PLANNING COMMISSION

Title of Item: **PLANNED UNIT DEVELOPMENT:** A request from Laketown Homes, LLC, for PUD Development Stage approval (Preliminary Plat), an IUP, and associated rezoning to a Planned Unit Development to establish 112 new lots on 42.5 unaddressed acres to the north of the Rum River Bluffs Planned Unit Development (informally known as the Siwek Farm); PID: 32-34-24-12-0001.

City of St. Francis Planning Department
Rivers Edge PUD Development Stage Plan Review

To: **Planning Commission**
From: Ben Gozola, City Planner
Meeting Date: **3-21-18**
Applicant: **T.H. Construction of Anoka Inc.**
Property Owner: (same)
Location: **Lots 24 through 35, Block 5, in Stone House Ridge 2nd Addition**
Zoning: **PUD (R2 Underlying zoning)**

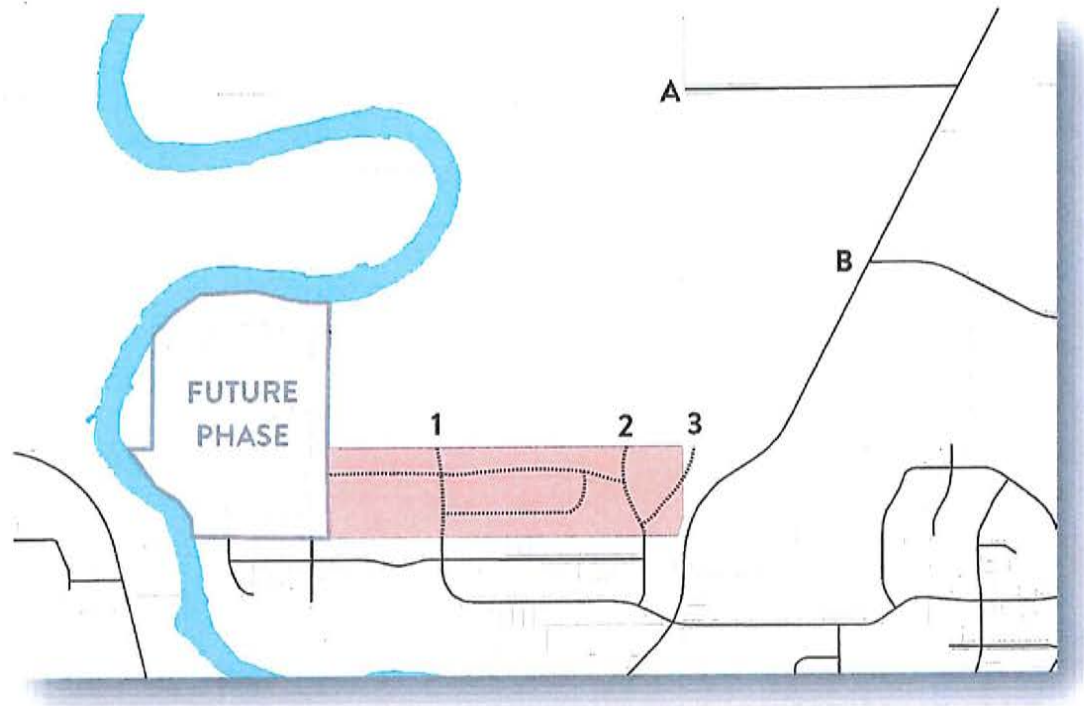
- (cont.)
- In this case, it appears that two (2) main deviations are being proposed within this PUD:
 1. As noted under setbacks, the applicant is proposing standard urban lot setbacks for all lots bordering the development's northern lot line. Technically by code, the rear yards adjacent to that property line should be the same as the adjacent zoning district requirement (35 feet); 25' setbacks are proposed. The side yard setbacks are the same (10').
 2. The other main deviation being considered is the incorporation of smaller detached townhome lots in the eastern portion of the development.

Staff believes that both deviations make sense for this site, and we believe they are in the long-term best interest of both the development and the City. Land to the north of this parcel is guided for future development by the City's comprehensive plan, and will eventually be platted into lots similar to those in Rum River Bluffs. Requiring an additional 10' to the required rear yard setback will not accomplish anything in the short term and serves no long-term benefit. Allowing the applicant to plat lots for patio homes geared towards retirees is an excellent step towards improving the City's life-cycle housing inventory.

PRELIMINARY SANITARY SEWER & WATERMAIN PLAN

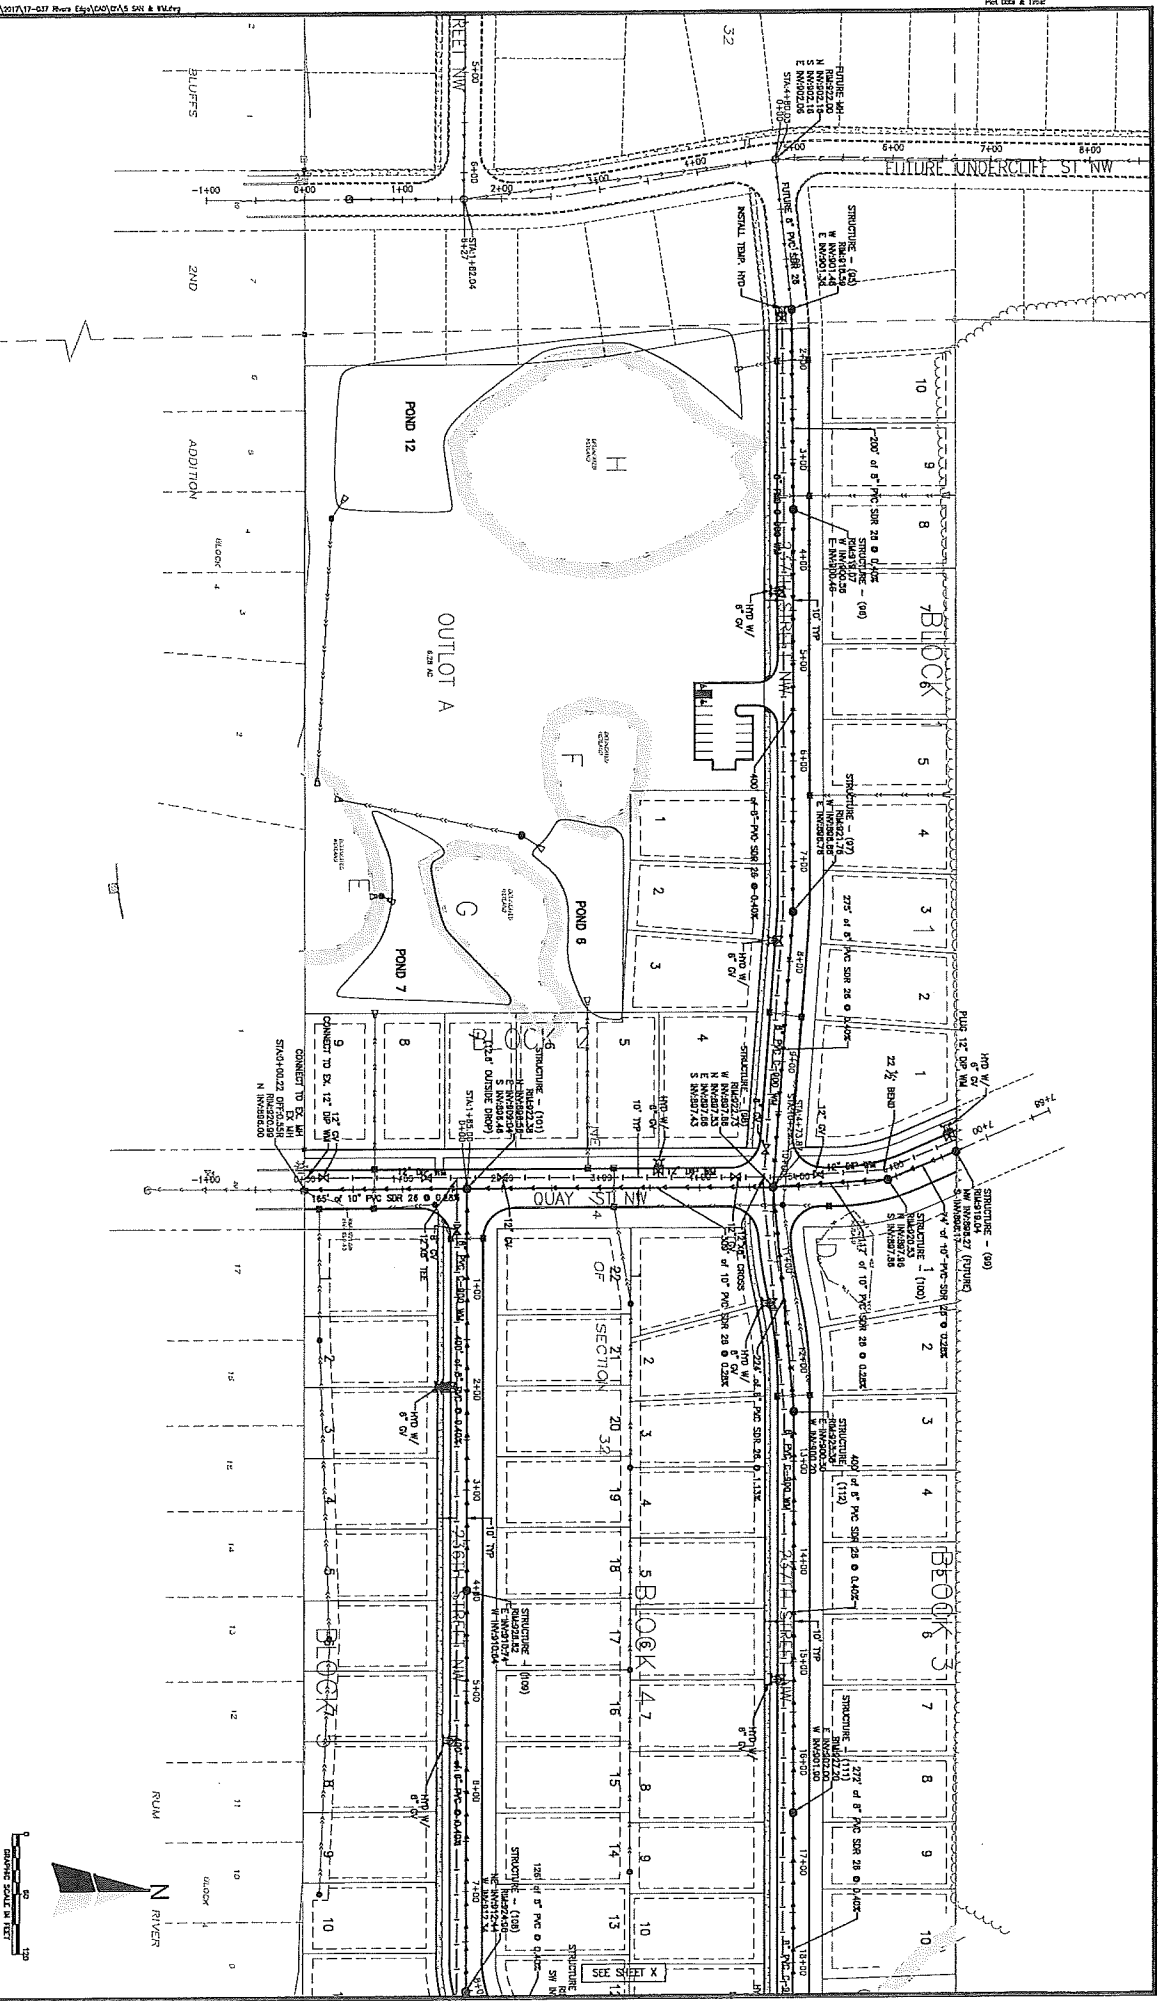
1. The plans propose to extend the existing 10" PVC sanitary sewer pipe north via the Quay Street alignment, which is acceptable and will provide sewer service to the property to the north.

2. The plans propose to extend a 12" DIP watermain north via the Quay Street alignment, which is acceptable and will provide water service to the property to the north.
3. The proposed sanitary sewer and water system appears adequate to service the proposed new lots.
4. The construction plans must include all applicable City standard details, which can be found here: <https://www.stfrancismn.org/commdev/page/private-development-standards>

PRELIMINARY STREET & STORM SEWER PLAN

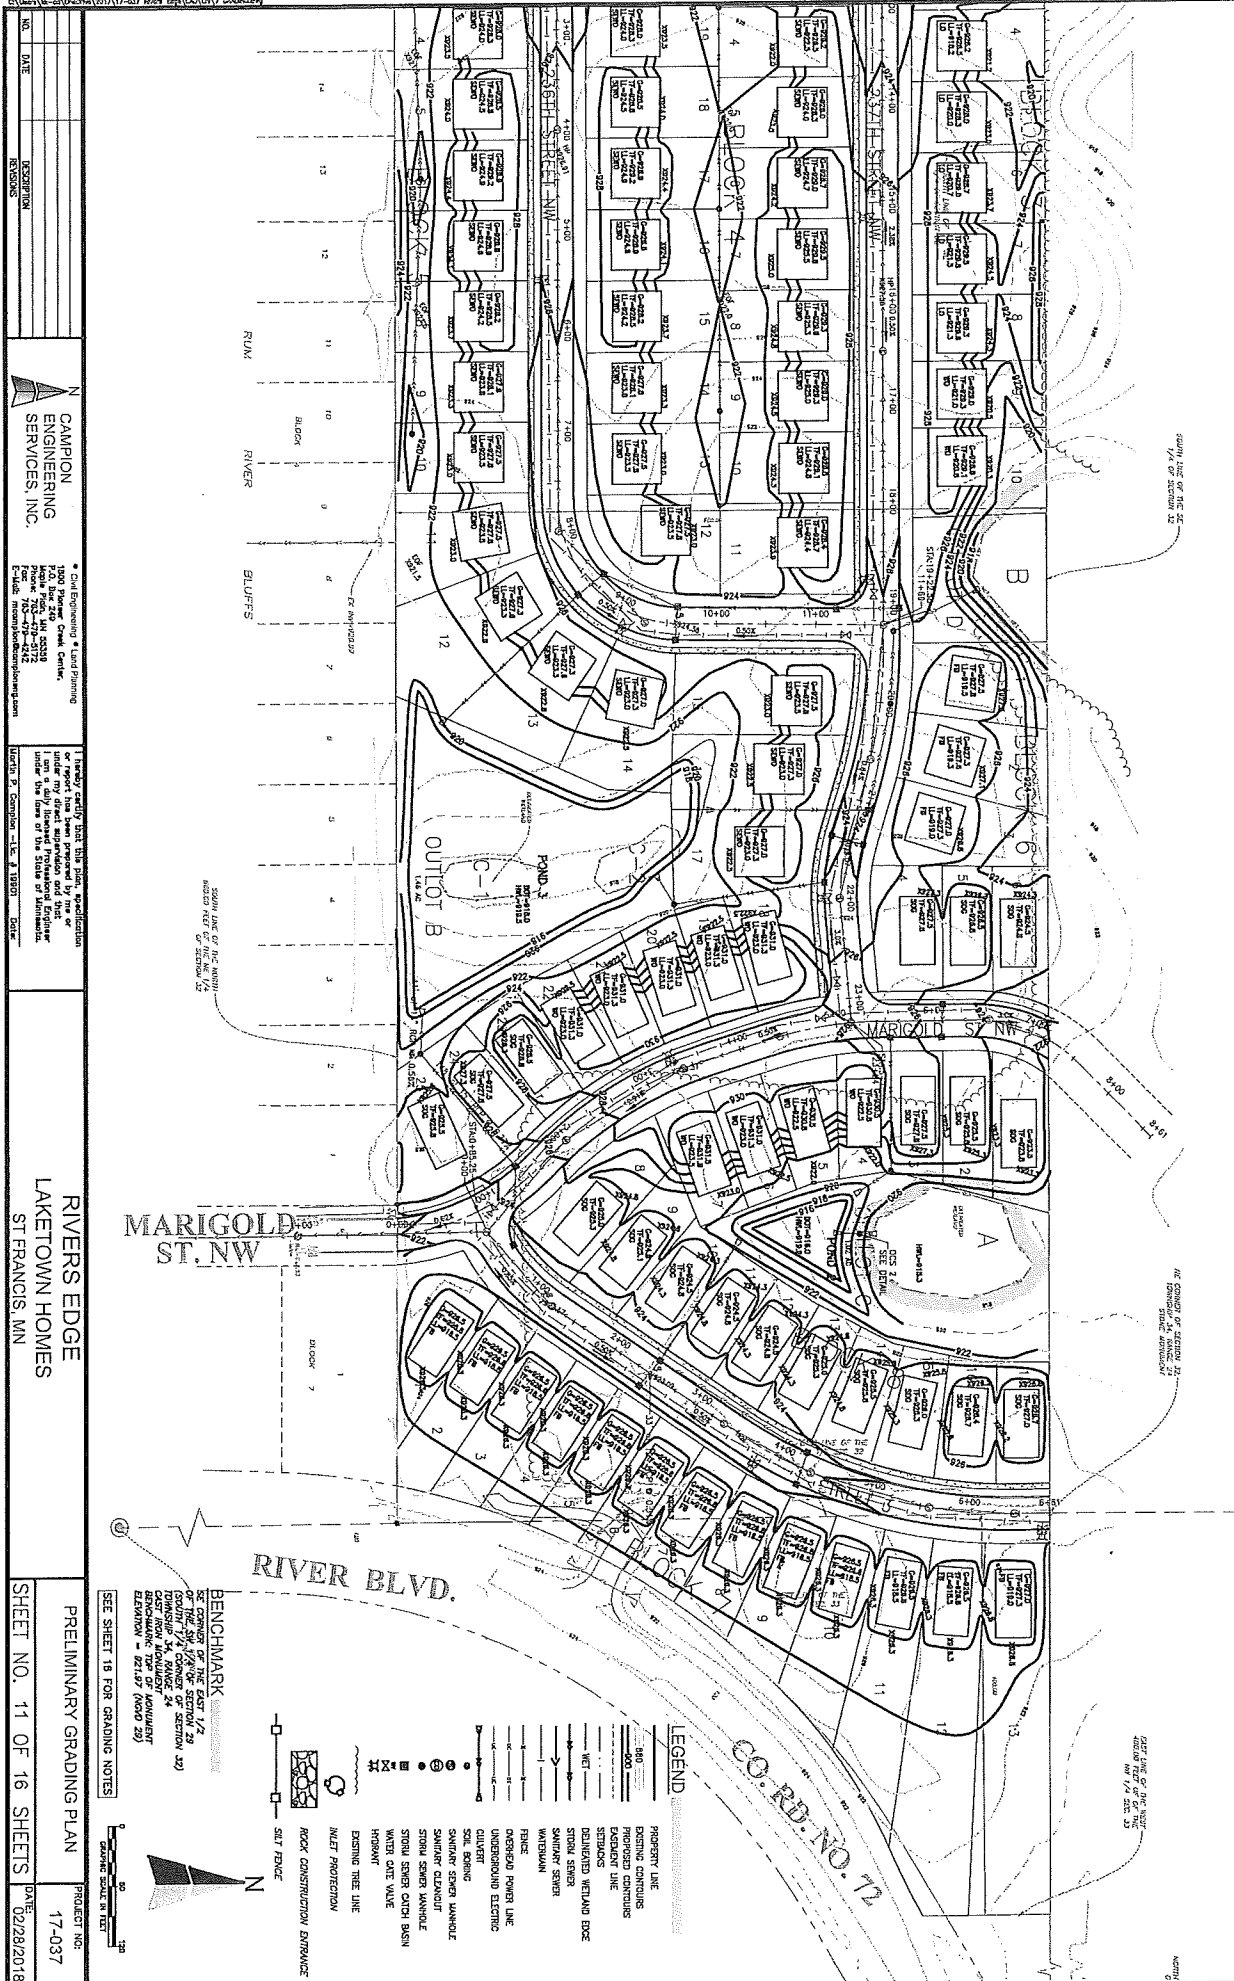
3. The street network generally appears adequate to provide access to the proposed new homes and provides connections to the existing development to the south, as well as future development to the north. The plans do not include horizontal curve information, however, all through streets shall be designed for a 30-mph design speed. All other streets must have a minimum horizontal curve radius of 200 feet. Also, street alignments shall be revised slightly such that they intersect at right angles.

PRELIMINARY GRADING PLAN
SHEET NO. 12 OF 16 SHEETS

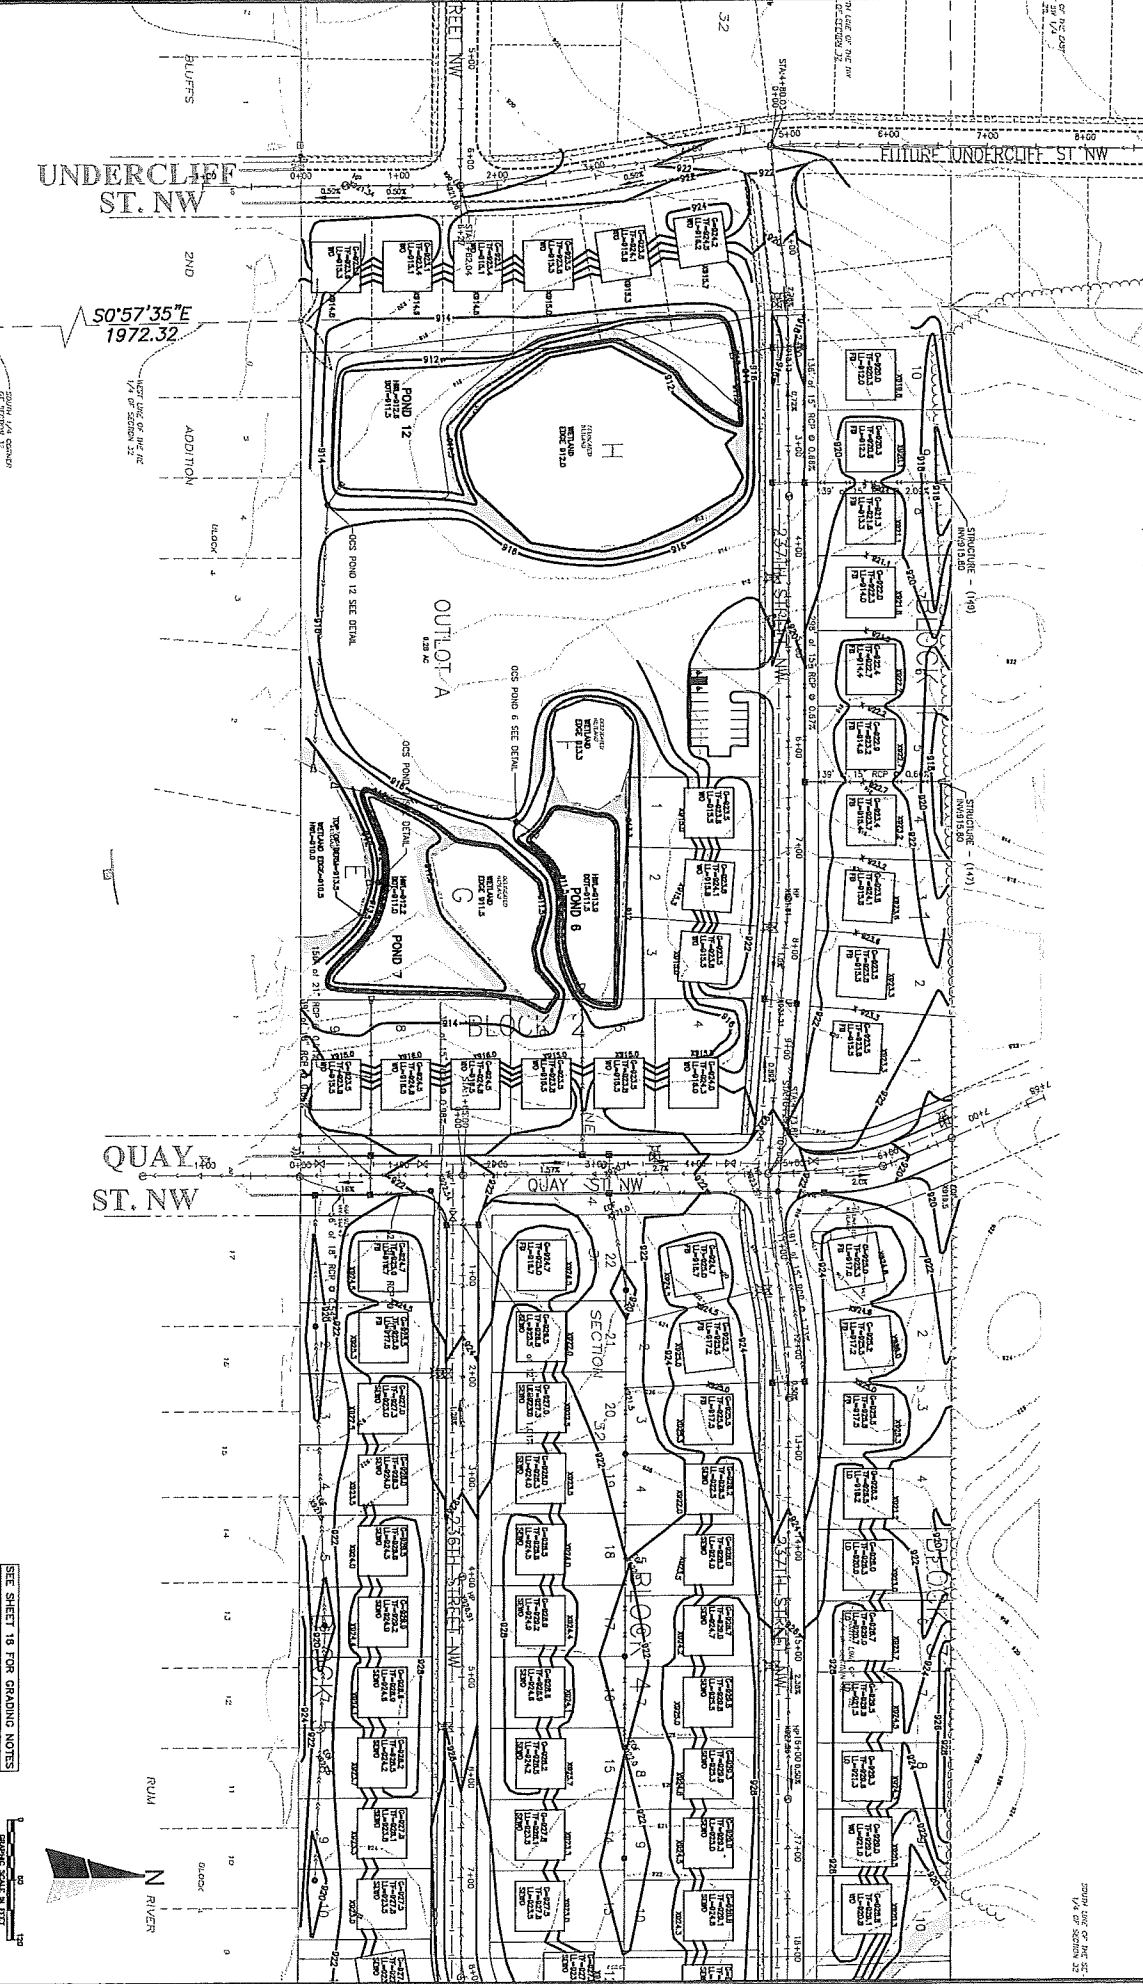
2. Add the borings to the grading plans and provide the groundwater information on the three piezometers.
 3. Emergency overflows shall be provided for all areas of ponding water to ensure flood protection to the new homes. Please incorporate into the design and/or clearly label.

4. The north edge of pond 3 and its outlet do not appear to be within a drainage and utility. Add the drainage and utility easements to the grading plan to ensure all flood and drainage ways are protected.

3. Add the borings to the grading plans and provide the groundwater information on the three piezometers.
4. Emergency overflows shall be provided for all areas of ponding water to ensure flood protection to the new homes. Please incorporate into the design and/or clearly label.

5. The north edge of pond 3 and its outlet do not appear to be within a drainage and utility. Add the drainage and utility easements to the grading plan to ensure all flood and drainage ways are protected.

Stone House Ridge End
 Lots 24-35, Block 5 Sketch

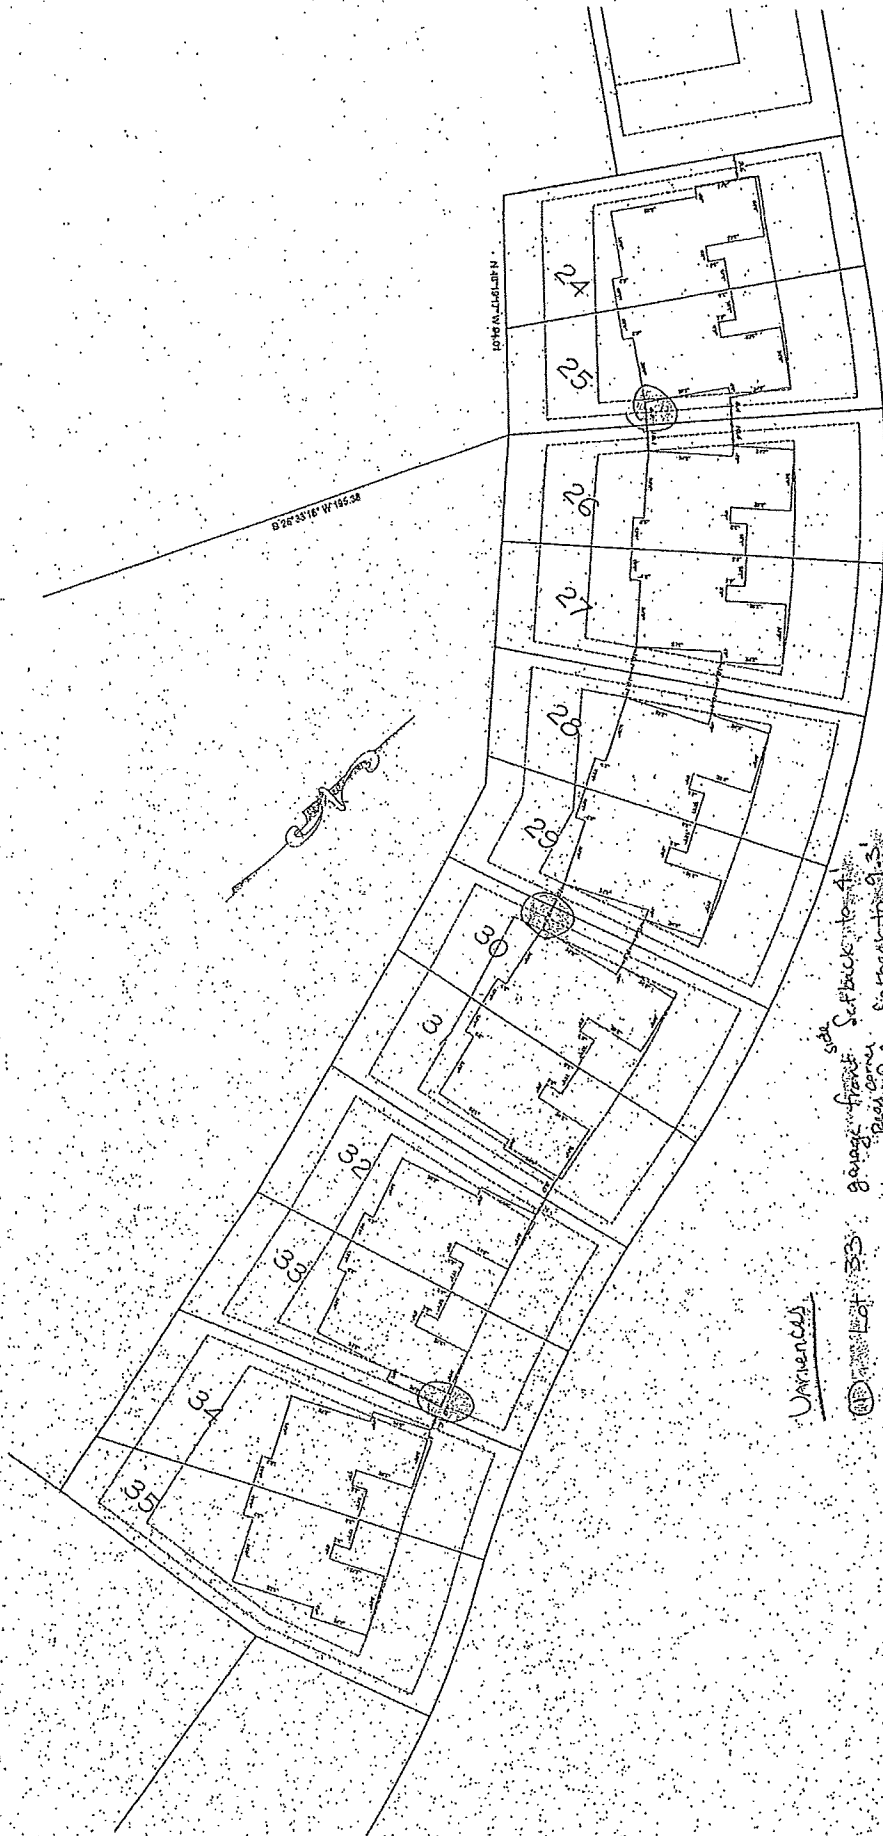
1. **A 1.1 foot side yard setback variance from the required 10 foot side yard setback for Lot 25.** The requested variance would place the adjacent homes 19.0 feet apart as opposed to 20.0 feet apart.
2. **A 0.7 foot side yard setback variance from the required 10 foot side yard setback for Lot 30.** The requested variance would place the two homes 19.4 feet apart as opposed to 20.0 feet apart.
3. **A 6.0 foot side yard setback variance from the required 10 foot side yard setback for Lot 33.** The requested variance would place the two homes 10.1 feet apart as opposed to 20.0 feet apart.
4. **A 3.9 foot side yard setback variance from the required 10 foot side yard setback for Lot 34.** The requested variance would place the two homes 10.1 feet apart as opposed to 20.0 feet apart.
